ADDENDUM No. 1
Relocate Taxiway A – Phase 2 Construction
May 17, 2024

Relocate Taxiway A – Phase 2 Construction

FAA AIP No. 3-19-0028-079

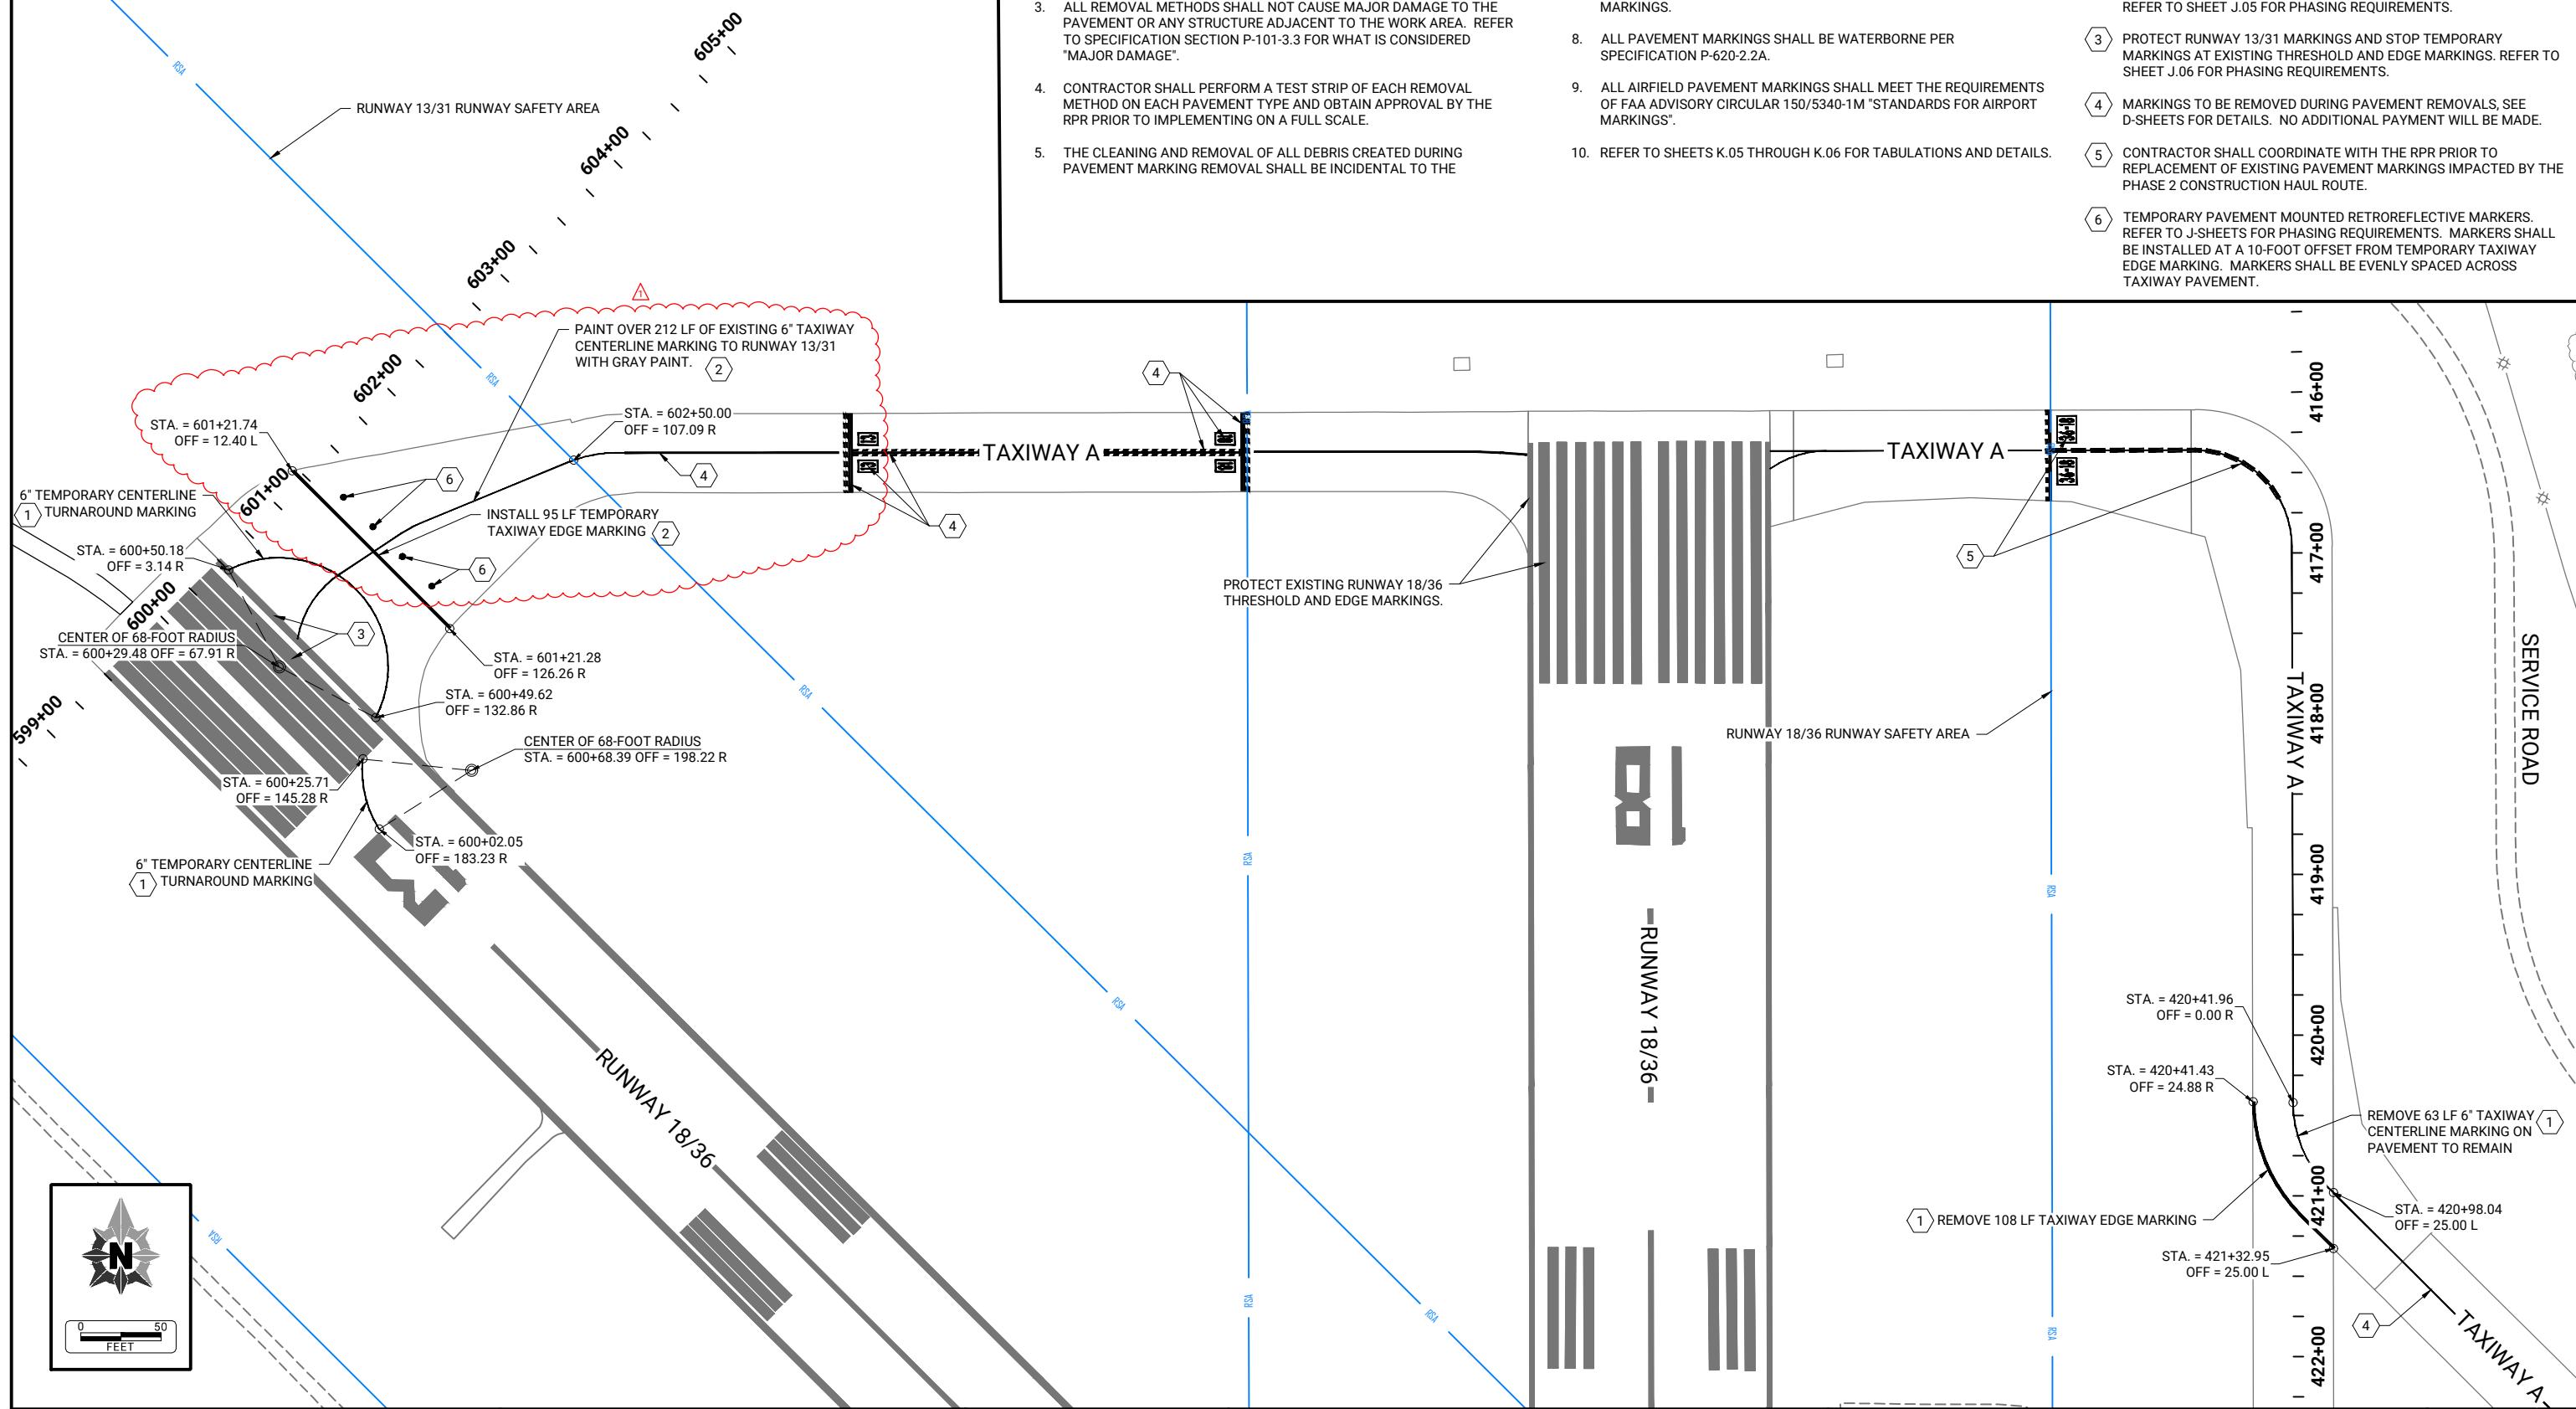
- Plan sheet is not being reissued.
- **Plan Sheet K.01 – Airfield Pavement Marking Plan**
 - **ADD** an additional pavement mounted retroreflective marker. Four temporary retroreflective markers are now required.

- **REVISE** callout stating that the existing 6” taxiway centerline marking shall be painted over with gray paint.
- **Plan Sheet L.04 – Geometrics, Staking, and Jointing**
